DEVELOPMENT APPLICATION ASSESSMENT REPORT

Application Number:	DA2021/2190
----------------------------	-------------

Responsible Officer:	Stephanie Gelder
Land to be developed (Address):	Lot 3 DP 391122, 546 Pittwater Road NORTH MANLY NSW 2100
Proposed Development:	Alterations and additions to a dwelling house
Zoning:	Warringah LEP2011 - Land zoned R2 Low Density Residential
Development Permissible:	Yes
Existing Use Rights:	No
Consent Authority:	Northern Beaches Council
Land and Environment Court Action:	No
Owner:	Michael John Squire Hilton Ava Thyrza Shirley
Applicant:	Ava Thyrza Shirley

Figure 1. Southern Elevation

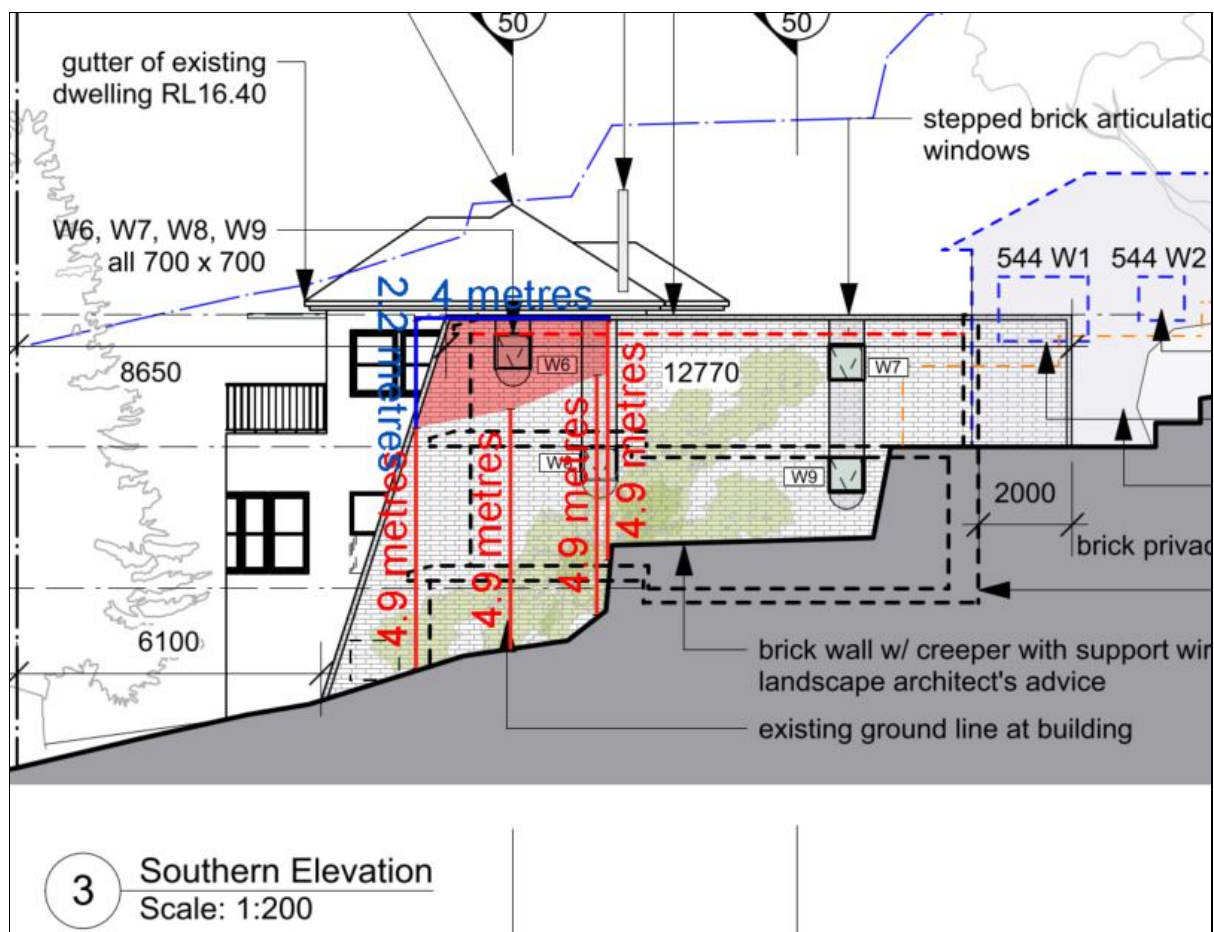
The proposal is sited outside of the building envelope on the south elevation as depicted in Figure 1. The southern facade encroaches outside of the building envelope for 2.2 metres in height for a horizontal length of 4 metres, resulting in a variation of 44.90% (2.2m). It is noted that there is an existing building envelope non-compliance due to the existing dwelling house, however this is not considered as part of the application.

In this instance, whilst the encroachment of the building envelope control is numerically non-compliant, the proposal demonstrates compliance with the objectives of the control as outlined below. Therefore, the variation to the building envelope control is considered to be supportable.
